Technical Bulletin Nr. 001-025

Applies to: Telescopic davits on Mitsui Ocean Fuji (Mariotti hull n.062) - Seabourn Sojourn (Mariotti hull n.063) - Seabourn Quest (Mariotti hull n.064)

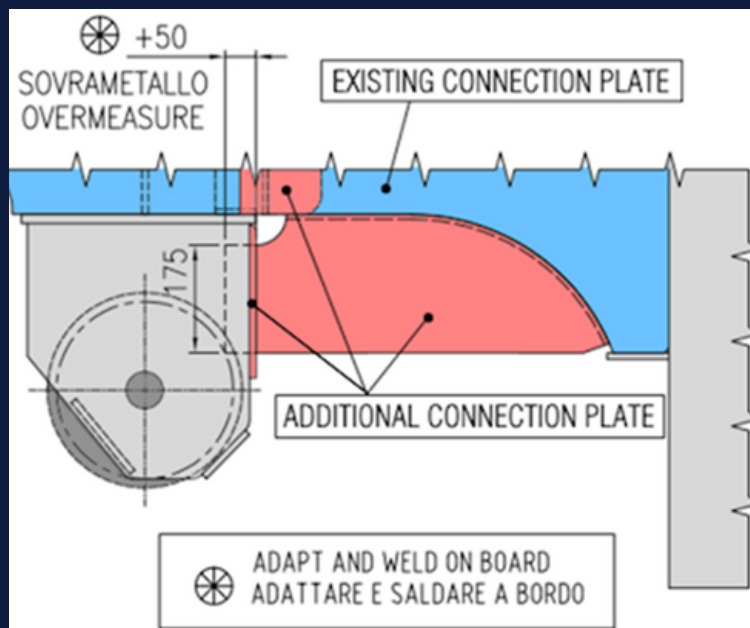
Navim Group recommends that the additional (reinforcing) plates are implemented on the two sister vessels, to improve the safety margin in case of the corrosion of the original hull connectors of the pulley boxes, as indicated below:

The additional plates are to be made of S355J2 plates, the welding is to be performed by certified welders.
